Drawing Status: PLANNING ALTERATIONS

Job Title: INDUSTRIAL DEVELOPMENT AT TAY LANE, GREENOGUE, RATHCOOLE, Co. DUBLIN

Drawing Title: BLOCK A - LIGHT INDUSTRIAL UNIT & ANCILLARY OFFICE/STAFF FACILITIES ELEVATIONS

Job No.: D1541 — Drawing No.: GA-A-A04 — Rev.: PL2

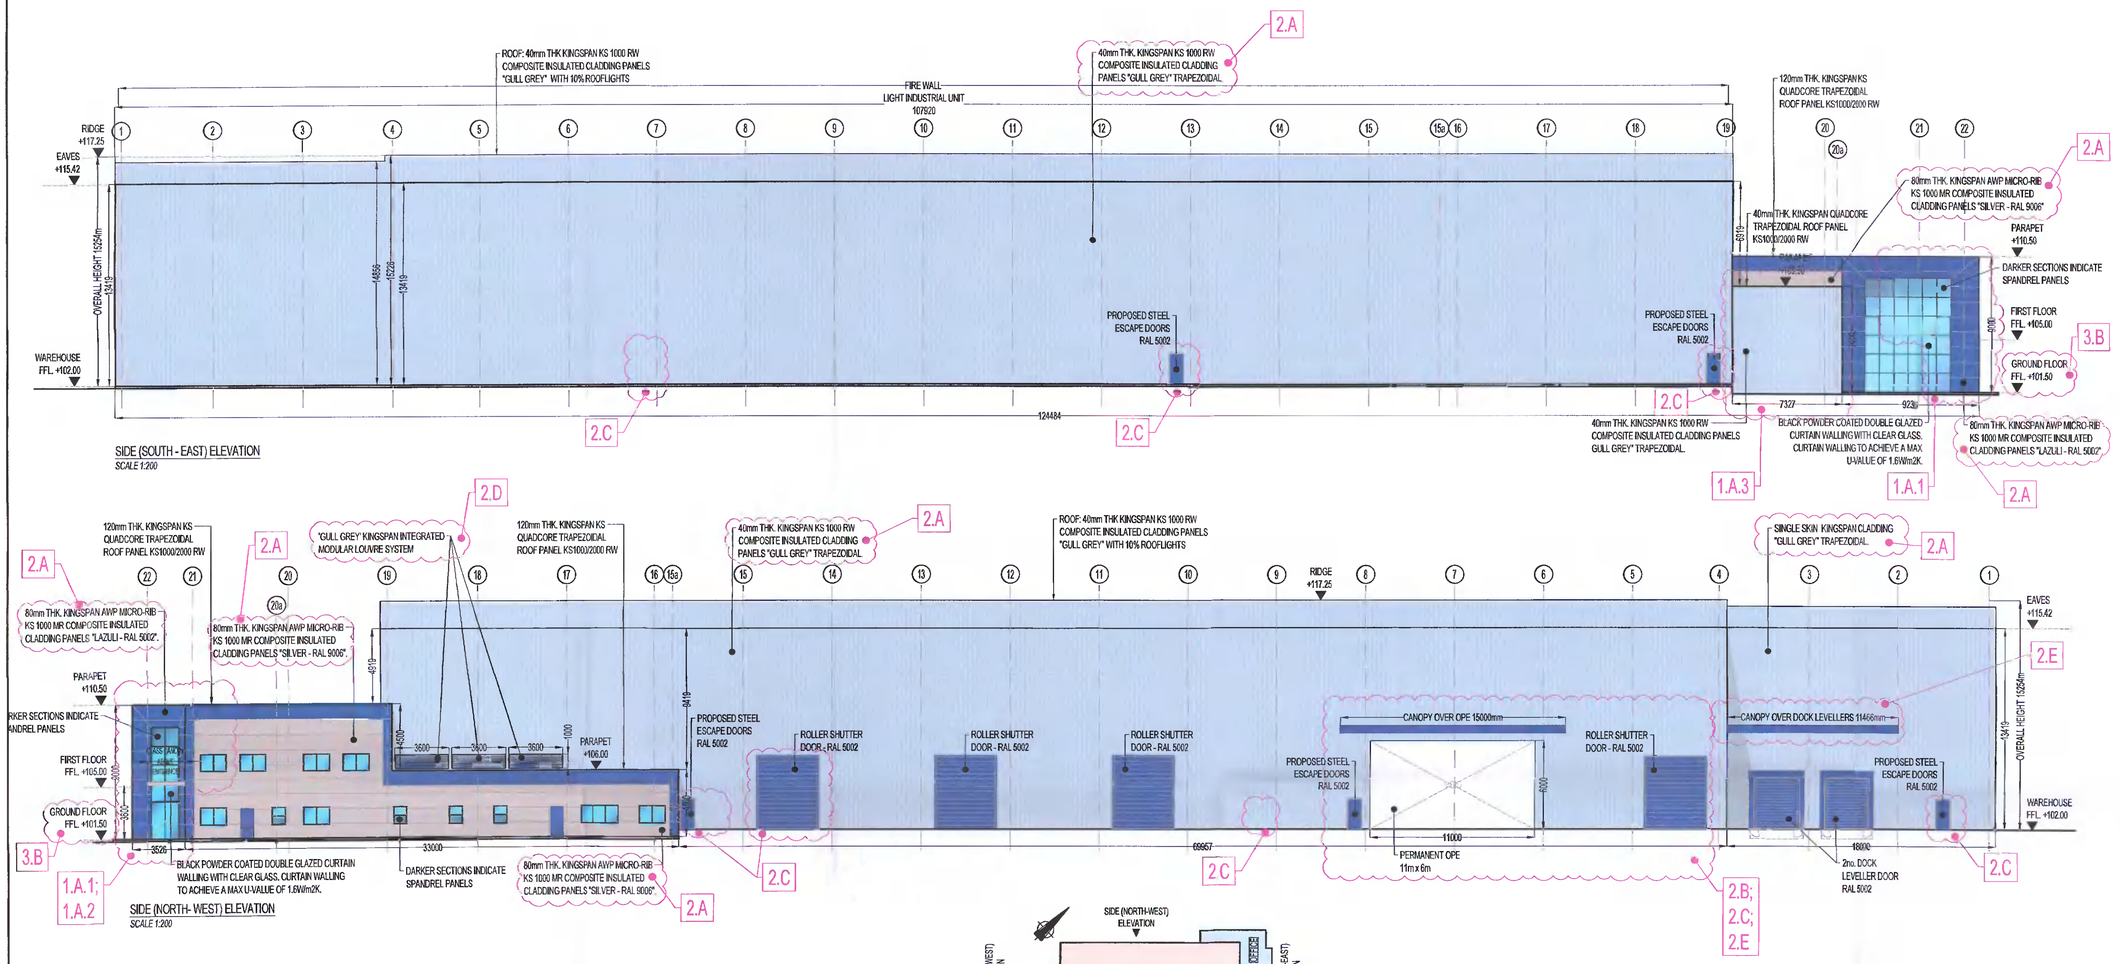
**1 2 3 ALTERATION NUMBER FOR SUBJECT APPLICATION**

2. ELEVATIONS ALTERATIONS AS PER LIST ABOVE PLUS ADDITIONAL ALTERATIONS AS FOLLOWS:

A. Provision of full height cladding (ground floor to roof) to Light Industrial Unit and ancillary Workshop;

B. Introduction of 11m wide x 6m high ope to Light Industrial Unit side (north-western) elevation;

C. Rearrangement of all fire exit & level access doors to Light Industrial Unit & ancillary Workshop, including omission and addition of the same;

D. Introduction of integrated modular louvre system to Light Industrial Unit rear (south-western) & side (north-western) elevation;

E. Introduction of canopies to the ancillary Office main entrance and above 11m wide ope & dock levellers to Light Industrial Unit side (north-western) elevation.
